REPORT TO THE LAKES VEGETATION AND LANDSCAPING COMMITTEE

PROJECT:
UF-626, New Conference Center at the University House

PROJECT:
Project #MP06934 , LMP Shared Use Path at Physics

MP06934
University of Florida
Landscape Master Plan
Physics Shared Use Path
Design Development Submittal

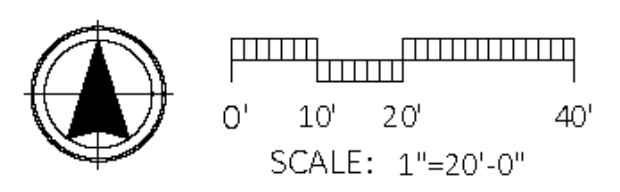
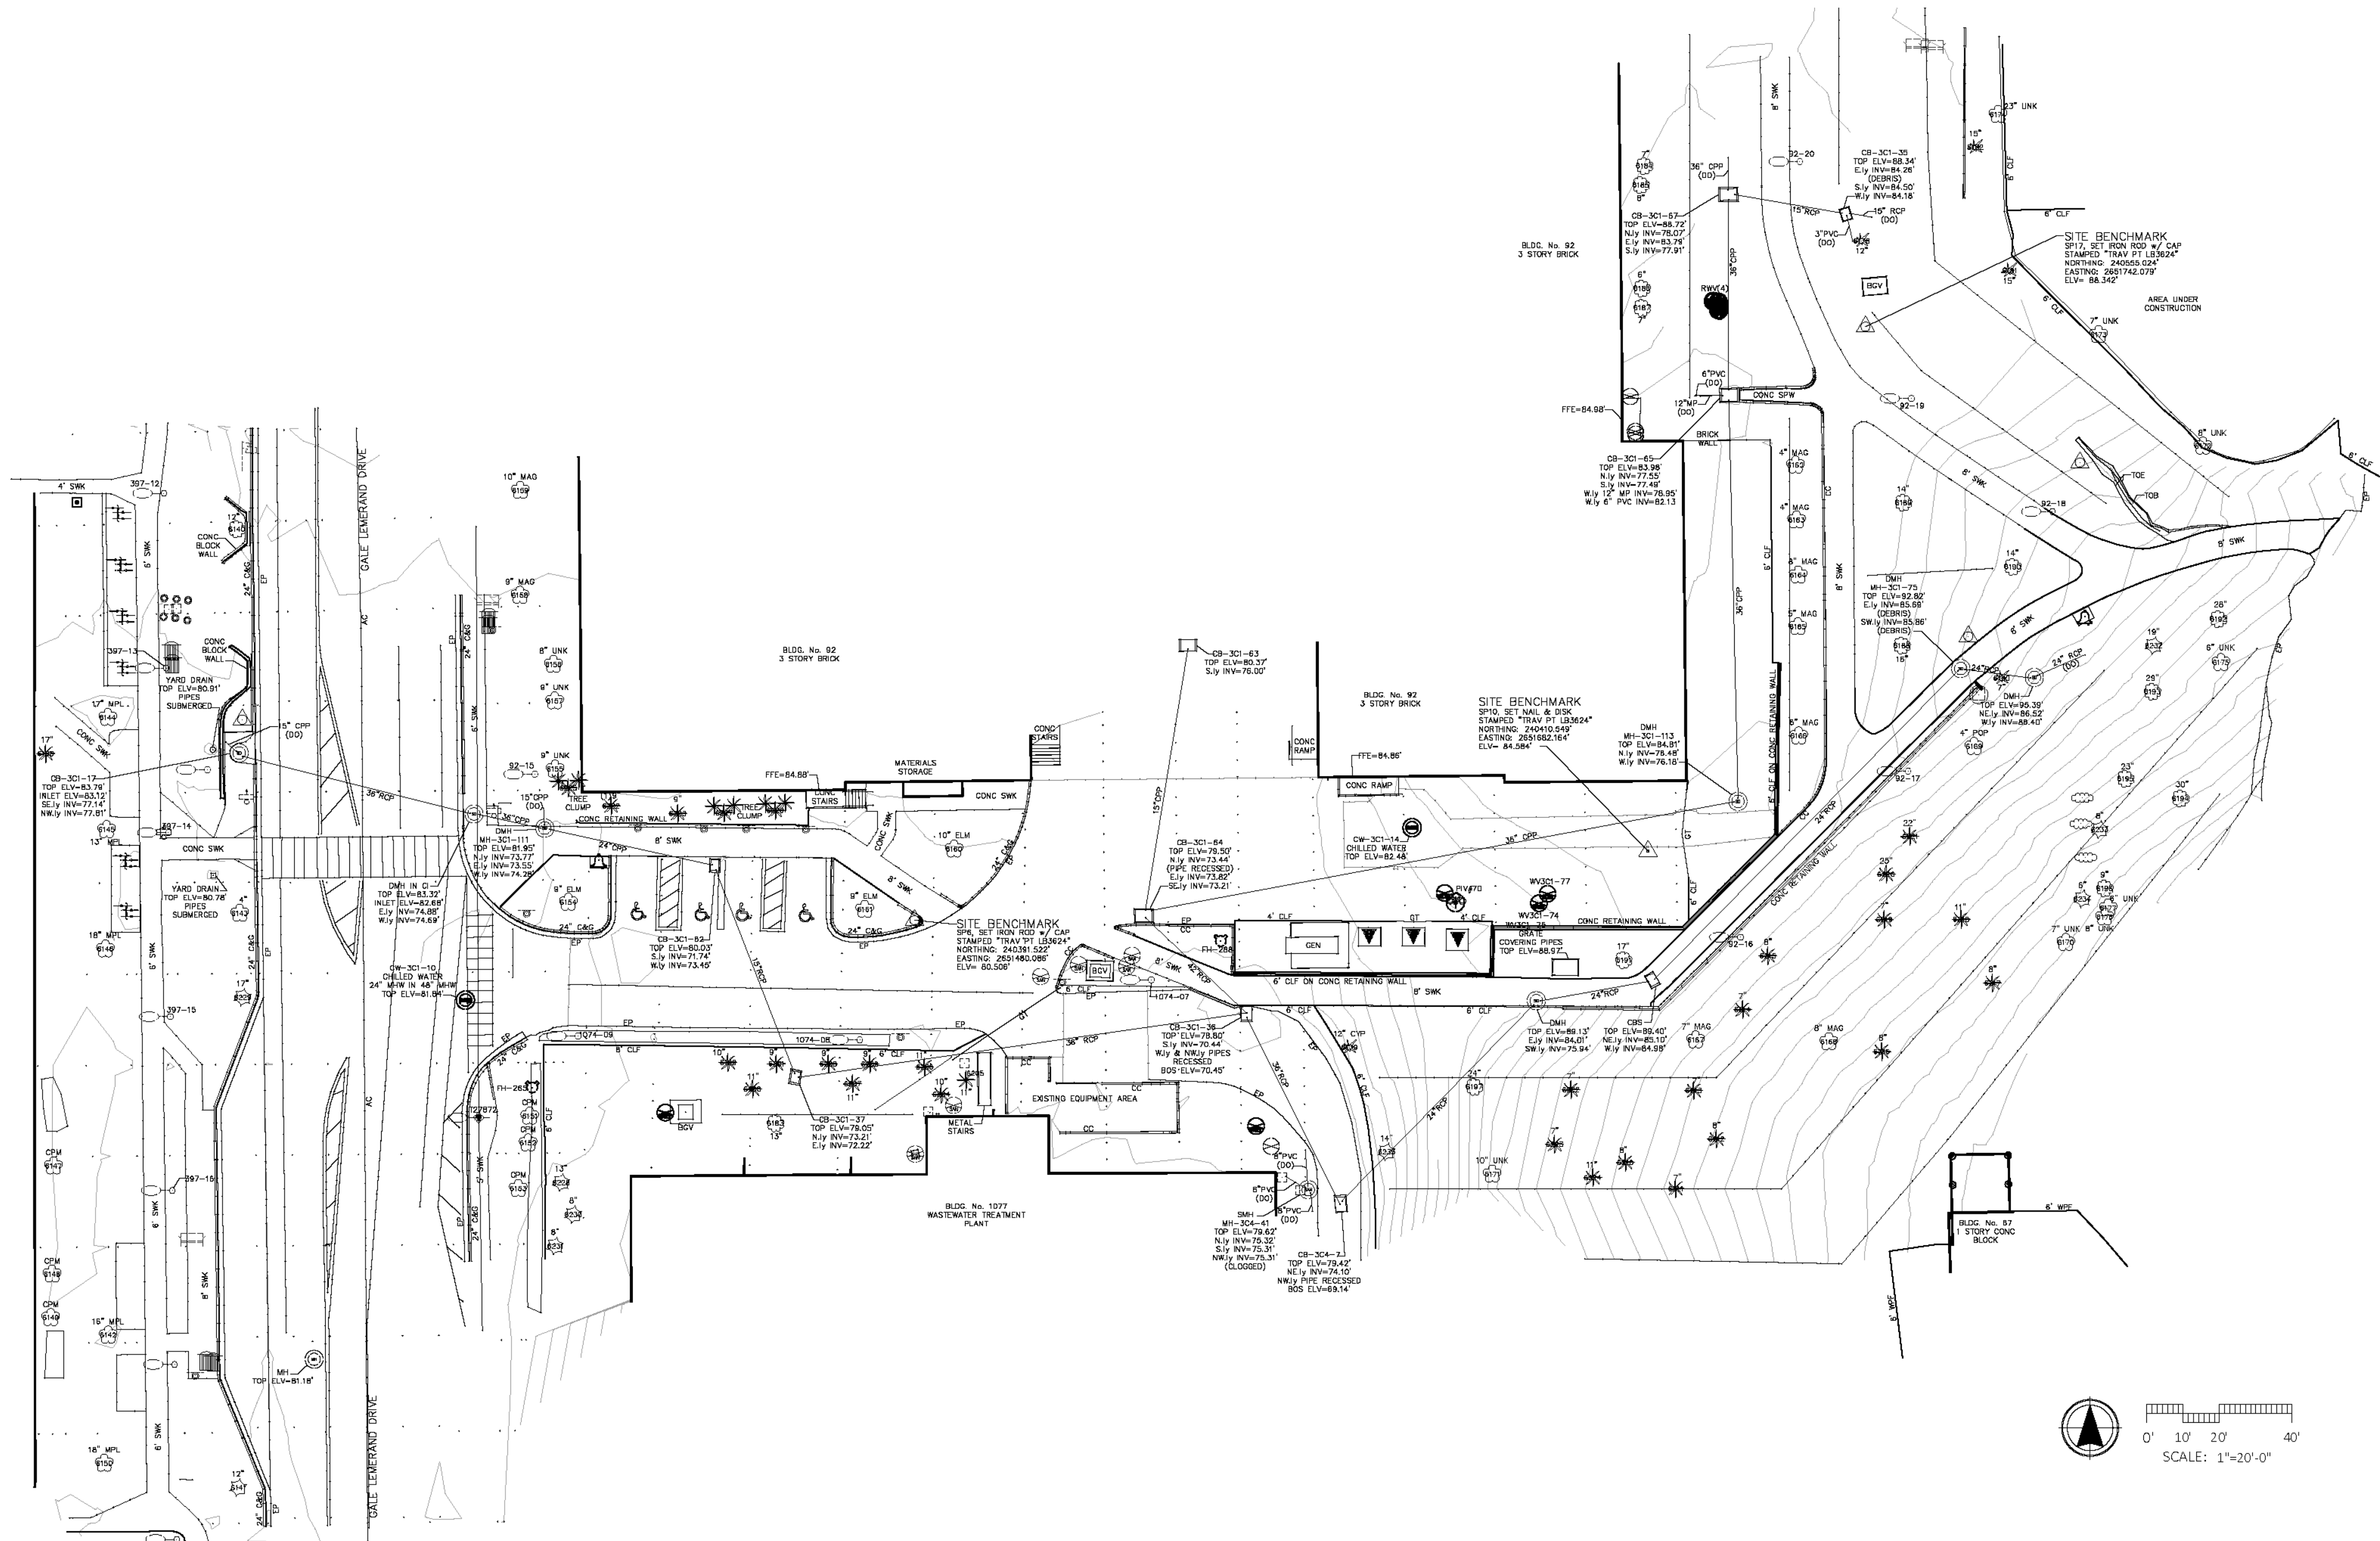
- Add **motor traffic control devices** to both ends of the shared-use path.
- **Shift crosswalk signals** on Gale Lemerand Dr southward to lineup with relocated crosswalk.

- Remove and relocate existing **UF Paving Mosaic**.

- **Accessibility** to helium tanks & loading area should remain clear.

- **Bollard lights are preferred** over pole lights due to reduced light pollution.
- Existing down-lights on-site work well. **Relocate existing down-lights** where possible.
- The **viewshed to the north** should remain clear of tall trees.
